Community Association Response

December 27, 2023

RE: DP2023-05567 | 321 10 ST NW | New: Dwelling Unit, Retail and Consumer Service (1 building), Sign – Class B (Fascia Sign – 3)

Figure 1: North Elevation - Design element (circled in yellow)

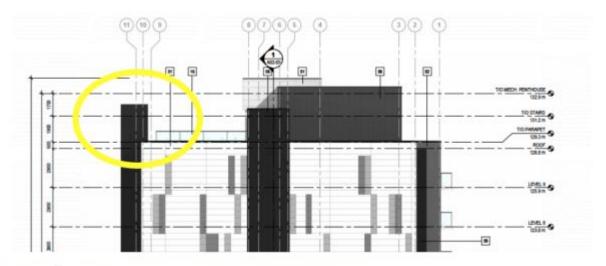
side of Norfolk Lane, due to the already narrow constraints this lane has.
Rendering Level 2 Floor Plan: Terraces	terrace is included in the calculation for the Floor Area Ratio as well as whether the exterior walls will be redesigned to increase the size of the dwelling units, which would result in the FAR increasing for the site.	
Rendering Building Elevations North Elevation: Height of the building	The HSPC recognizes there are three heights that have been identified. The height to the roof is 28.8m, the height to the parapet is 29.3m, and the height of the stairs 31.2m. There is also a height that has not been identified and that is the height of the design feature (Figure 1) located on the east side of the building.	The HSPC recognizes that ancillary structures are not included in the overall height calculation. Are stairs a component of the ancillary structure? If not, then what does the maximum height pertain to – roof or parapet? For the design feature (figure 1), what is the maximum height and is this part of the overall height of the building?
